Subject: **Nationwide 12 & 33 Permit Application and Buffer Certification Modification** for the replacement of Bridge No. 30 over Green Mill Run on SR 1703 in Pitt County, Division 2. Federal Project No. BRSTP-1703(1), State Project No. 8.2221601, T.I.P. No. B-3685.

**SUBJECT: Response to the § 401 Water Quality Certification (DWQ Project No. 040995) requesting more information, TIP No. B-3685.**

**Re: Permit Application for proposed replacement of Bridge No. 30 over Green Mill Run on SR 1703 in Pitt County, Division2, TIP No. B-3685, DWQ No. 040995**

16" WATER LINE, 8" WATER LINE, AND  
6" GAS LINE STREAM CROSSING DETAIL

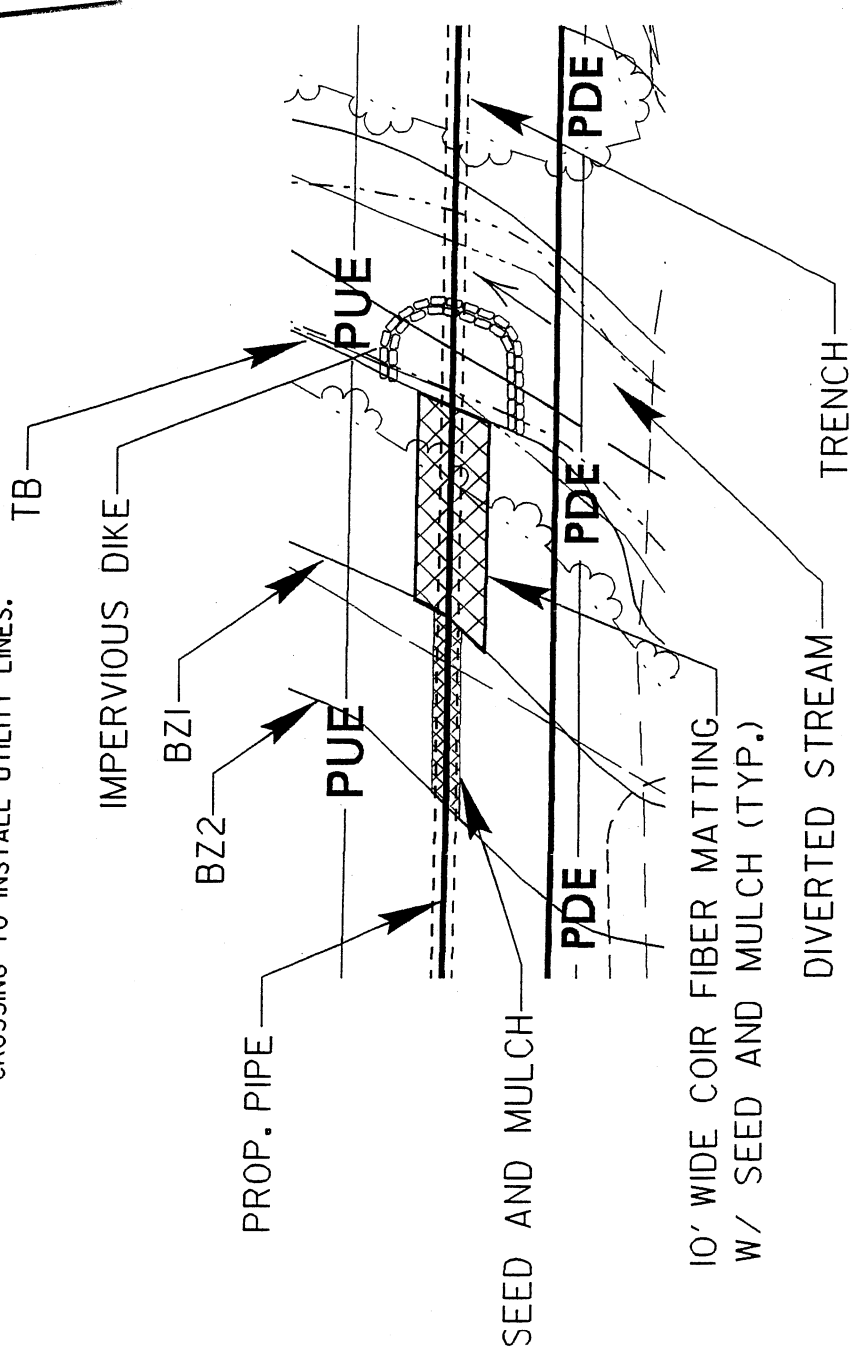
***NCDWQ Deficiency:** There are 2 structures on the north and south sides of the bridge that extend beyond the bridge. The north side structures start at approximately STA. 15+00 and extend to approximately STA. 20+010. The south side structures start at approximately STA. 16+00 and extend to approximately STA. 20+00. What are these structures?*

- ✓ There are 2 structures on the north and south sides of the bridge that extend beyond the bridge. The north side structures start at approximately STA. 15+00 and extend to approximately STA. 20+00. The south side structures start at approximately STA. 16+00 and extend to approximately STA. 20+00. What are these structures?

**NCDOT Response:** The structures shown on each side of 14th Street are proposed utility relocations. They consist of the relocation of a 16" water and 8" sewer on the North side and a 8" water and 6" gas on the South side.
